# UNITED STATES PATENT AND TRADEMARK OFFICE

APPLICATION NO.	FILING DATE	FIRST NAMED INVENTOR	ATTORNEY DOCKET NO.	CONFIRMATION NO.
10/588,167	12/02/2008	Ralf Wirth	12406-212US1 P2004,0150 U	5063
26181 7590 03/21/2012 FISH & RICHARDSON P.C. (SV) PO BOX 1022 MINNEAPOLIS, MN 55440-1022			EXAMINER WOLDEGEORGIS, ERMIAS T	
			ART UNIT 2893	PAPER NUMBER
			NOTIFICATION DATE 03/21/2012	DELIVERY MODE ELECTRONIC

<b>Office Action Summary</b>	<b>Application No.</b> 10/588,167	<b>Applicant(s)</b> WIRTH ET AL.	
	<b>Examiner</b> ERMIAS WOLDEGEORGIS	<b>Art Unit</b> 2893

## DETAILED ACTION

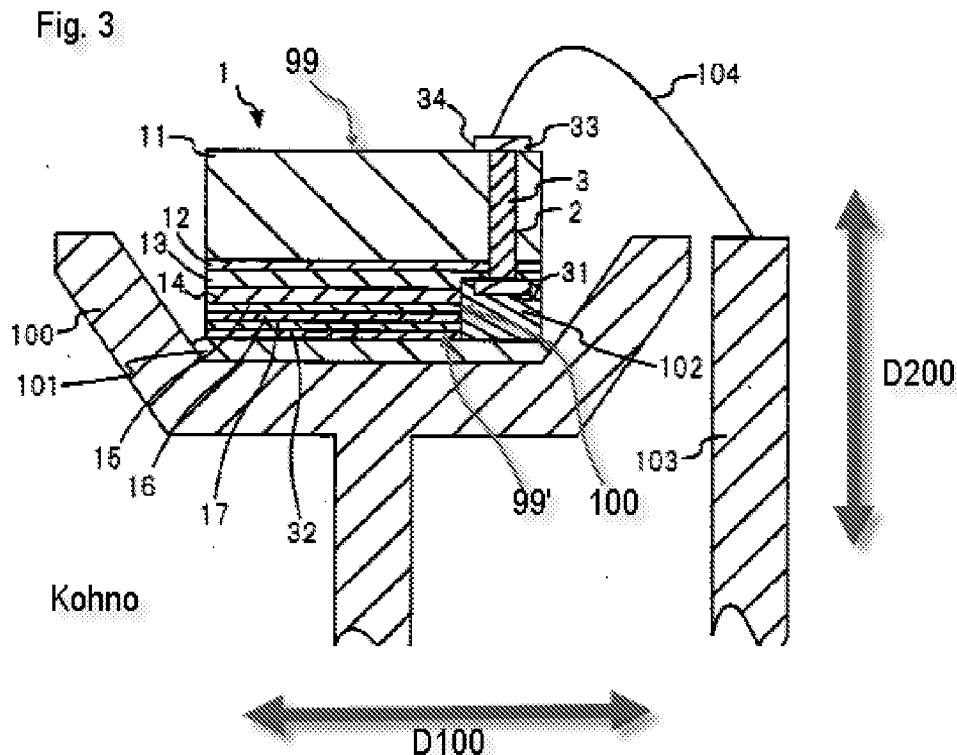
In regards to claim 1, Kohno discloses (Fig. 3, See annotated and attached Fig. 3 below) an optoelectronic component comprising a semiconductor function region (**14+15+16**) with an active zone (**15**) and a lateral main direction of extension (**D100**), wherein said semiconductor function region (**14+15+16**) is provided with at least one opening (**10**) through said active zone (**15**) in a direction orthogonal to the main direction (**D100**), and disposed in the region of said opening (**10**) is a connecting conductor material (**31**) that is electrically isolated from said active zone (**15**) at least in a subregion of said opening.

In regards to claim 2, Kohno discloses (Fig. 3, See annotated and attached Fig. 3 below) an optoelectronic component comprising a semiconductor function region **(14+15+16)** with an active zone **(15)** and a lateral main direction of extension **(D100)**, wherein said semiconductor function region **(14+15+16)** is provided with a lateral side face **(100)** bounding said active zone **(15)**, and disposed after said side face **(100)** in the lateral direction is a connecting conductor material **(31)** that is electrically isolated from said active zone **(15)** at least in a subregion of said side face **(100)**.

In regards to claim 3, Kohno discloses (Fig. 3, See annotated and attached Fig. 3 below) said connecting conductor material **(31)** is at least partially electrically isolated from said active zone **(15)** by an isolation material **(102)**.

In regards to claim 4, Kohno discloses (Fig. 3, See annotated and attached Fig. 3 below) said opening **(10)** is configured as a depression in the lateral direction **(D100)** or said side face **(100)** is provided with a depression in the lateral direction **(D100)**.

In regards to claim 5, Kohno discloses (Fig. 3, See annotated and attached Fig. 3 below) said isolation material **(102)** at least partially lines said opening **(10+2)**.

In regards to claim 6, Kohno discloses (Fig. 3, See annotated and attached Fig. 3 below) said opening **(10)** extends in the vertical direction **(D200)** all the way through said semiconductor function region **(14+15+16)**.

In regards to claim 8, Kohno discloses (Fig. 3, See annotated and attached Fig. 3 below) said connecting conductor material **(31)** is electrically isolated from said second main face **(99')** of said semiconductor function region **(14+15+16)**.

In regards to claim 13, Kohno discloses (Fig. 3, See annotated and attached Fig. 3 below) said semiconductor function region (**14+15+16**) is disposed on a carrier (**11**).

In regards to claim 14, Kohno discloses (Fig. 3, See annotated and attached Fig. 3 below) said connecting conductor material (**31**) extends to a side of said carrier (**11**) that is opposite said semiconductor function region (**14+15+16**).
